NLS2005017
March 8, 2005

Subject: License Amendment Request to Revise Technical Specifications - Single Loop
Operation Safety Limit Minimum Critical Power Ratio
Cooper Nuclear Station, Docket 50-298, DPR-46

**License Amendment Request to Revise Technical Specifications
Single Loop Operation Safety Limit Minimum Critical Power Ratio**

Cooper Nuclear Station

Figure 1
Reference Loading Pattern – Cooper Nuclear Station Cycle 22

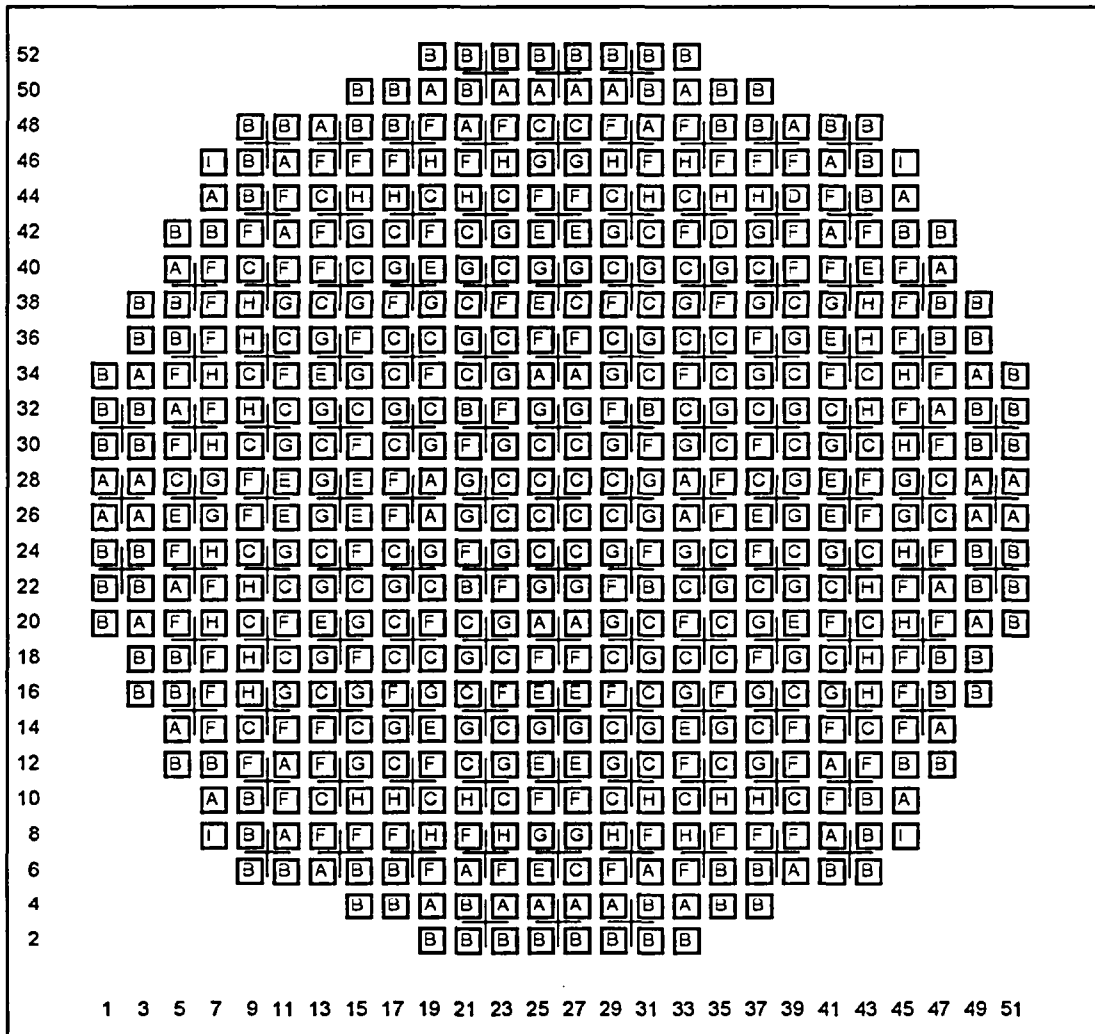
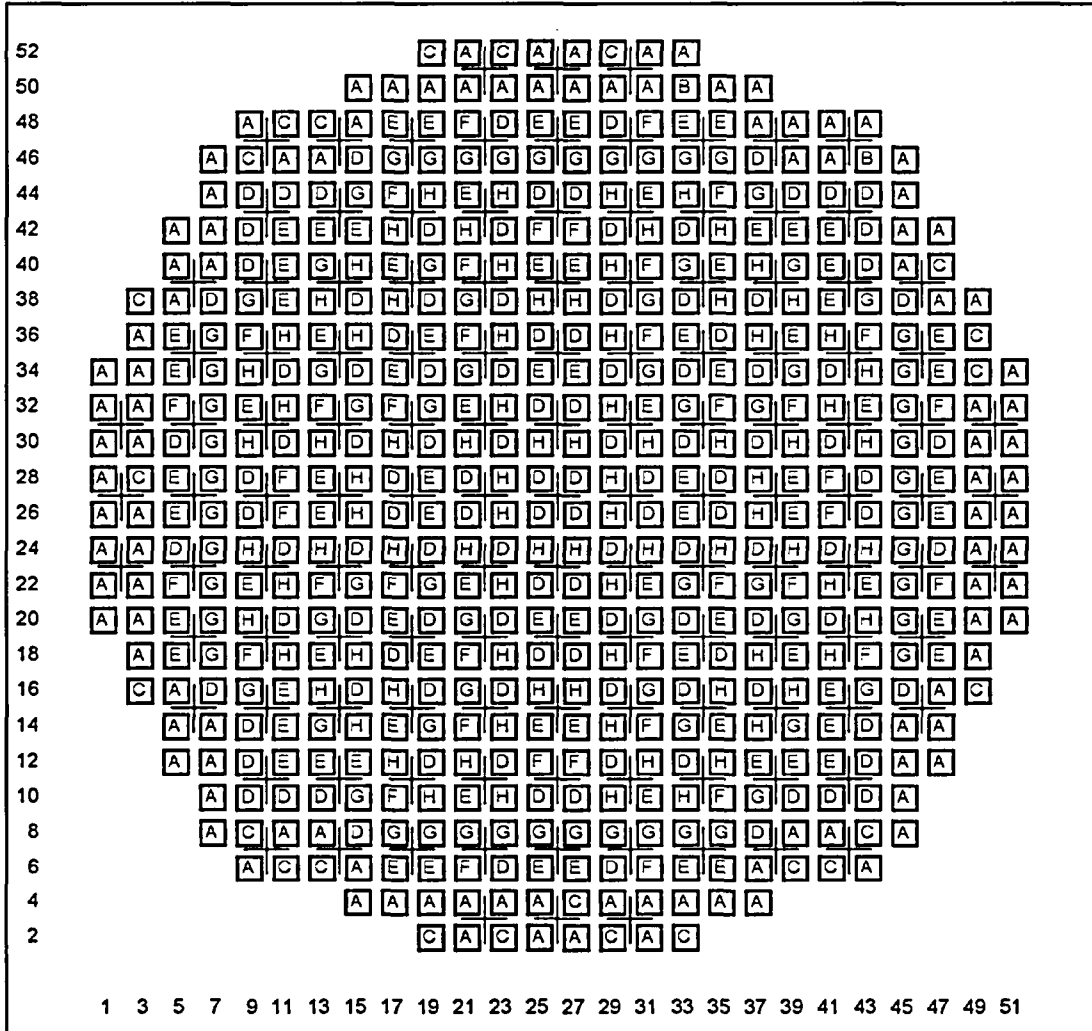
The core loading information for Cooper Nuclear Station Cycle 22 is provided in Figure 1. For comparison the core loading information for Cooper Nuclear Station Cycle 23 is provided in Figure 2. The impact of the fuel loading pattern differences on the calculated SLMCPR is correlated to the values of MIP (MCPR Importance Parameter) and RIP (R-factor Importance Parameter). The MIP and RIP values for both cycles are provided in Table 1.
